ISSUE	APP'D	DATE
FOR COMMENT		04/03/19

OPTION B

BRIGHTON TRAINING CENTRE

OFF CHUTE

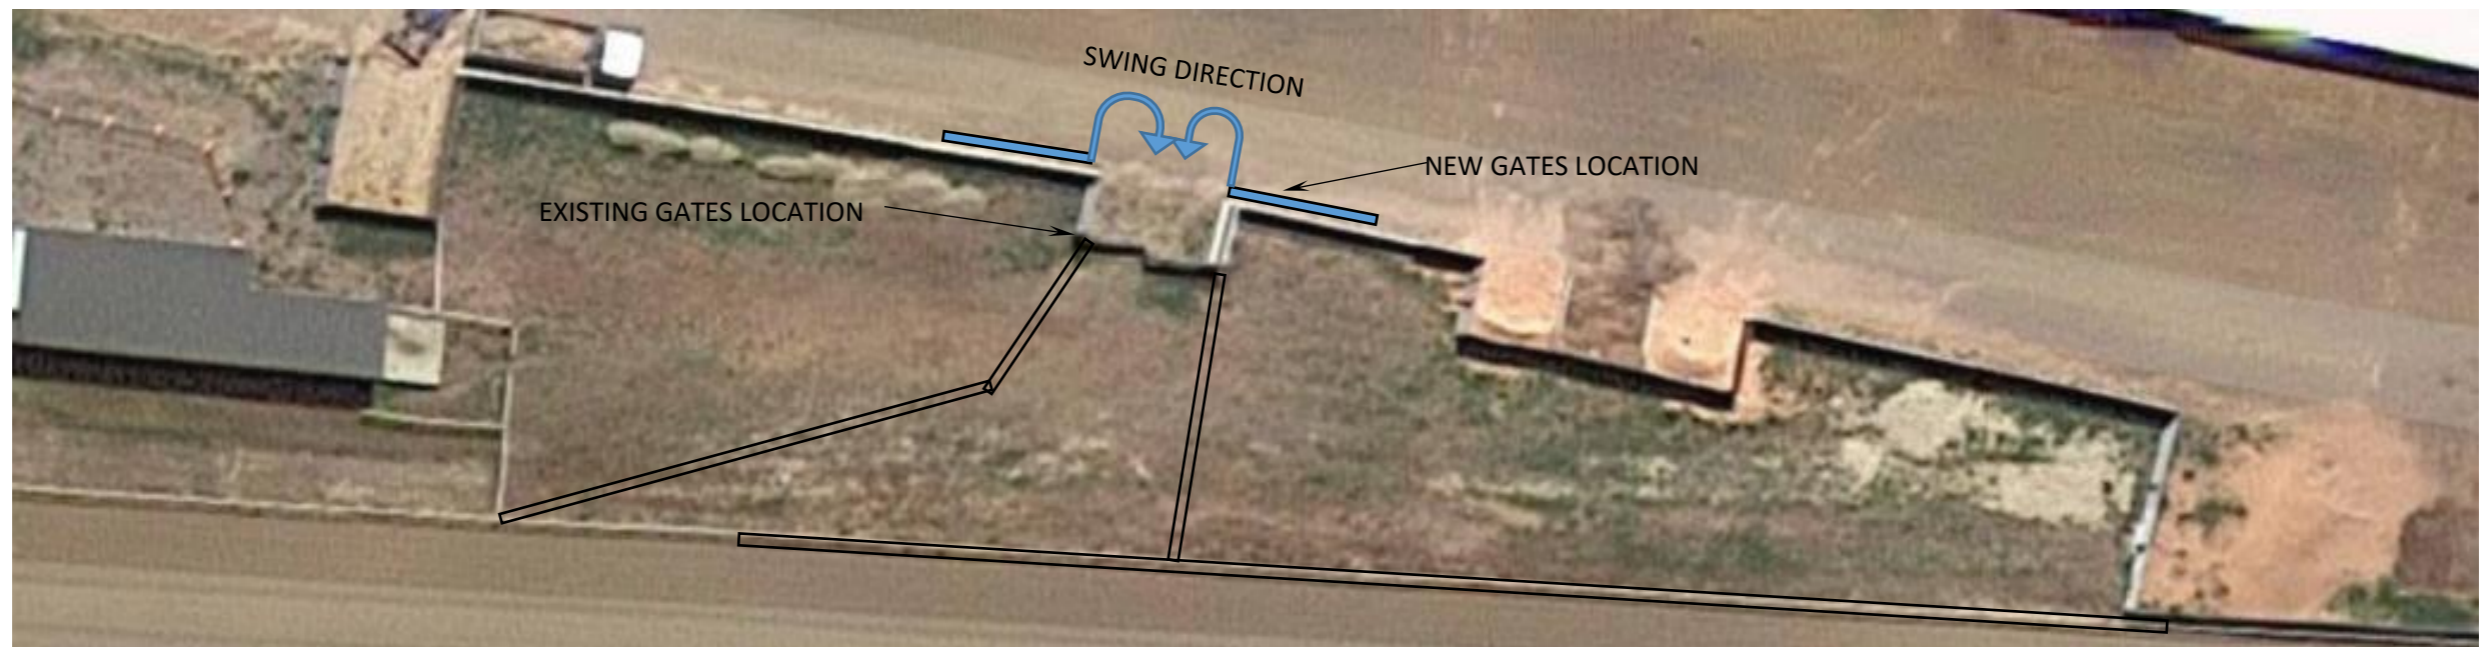
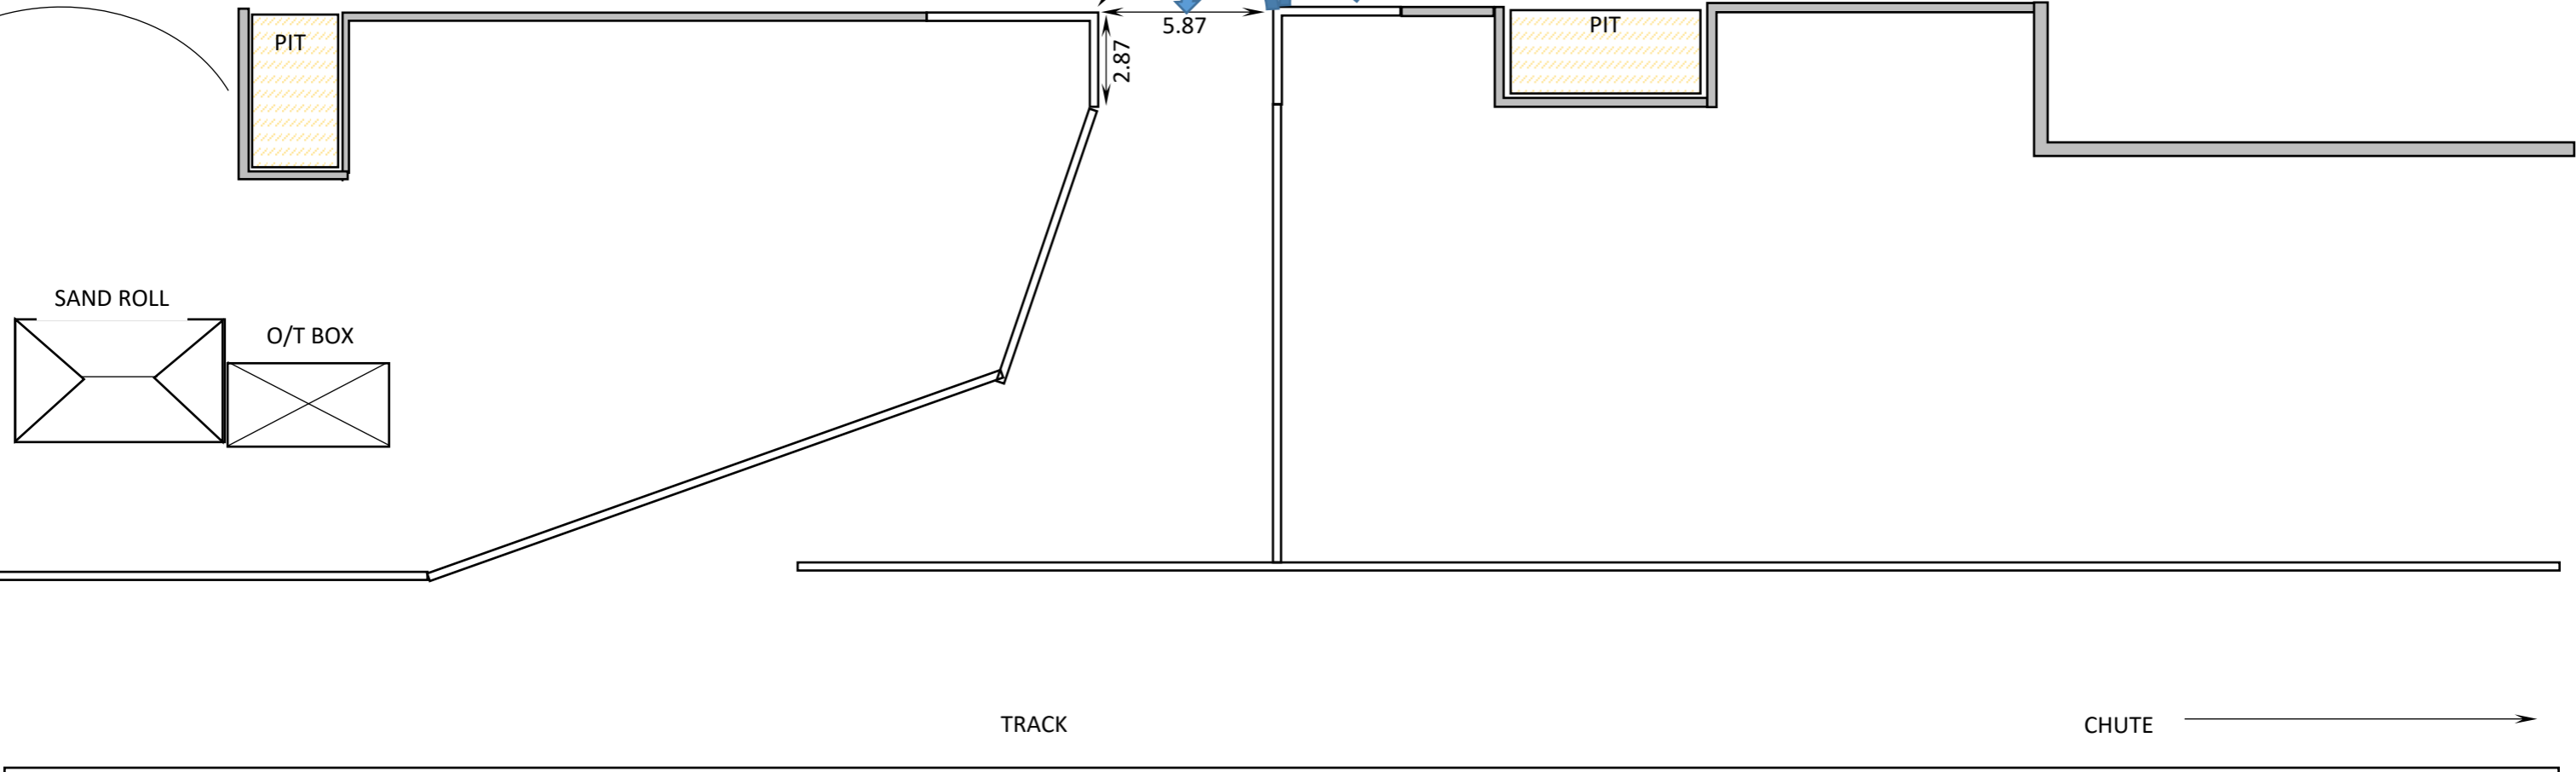
REMOVE INTERNAL SWING GATES
TO EXTERNAL SWING GATES.
ALLOWS EASIER ACCESS TO CLOSE
HORSE IN

- ALL DIMENSIONS ARE IN METERS UNLESS NOTED OTHERWISE
850mm OF COLOURBOND FENCING TO BE REMOVED FROM TOP OF FENCE LINE AND REPLACED WITH 50 x 50 4 GAUGE HOT DIPPED GALV MESH. TOTAL OF 96M. AREA ON TOP DWG IN GREY INCLUDED IN CALCULATION. COLOURBOND ALONG TRACK TO REMAIN INTACT.
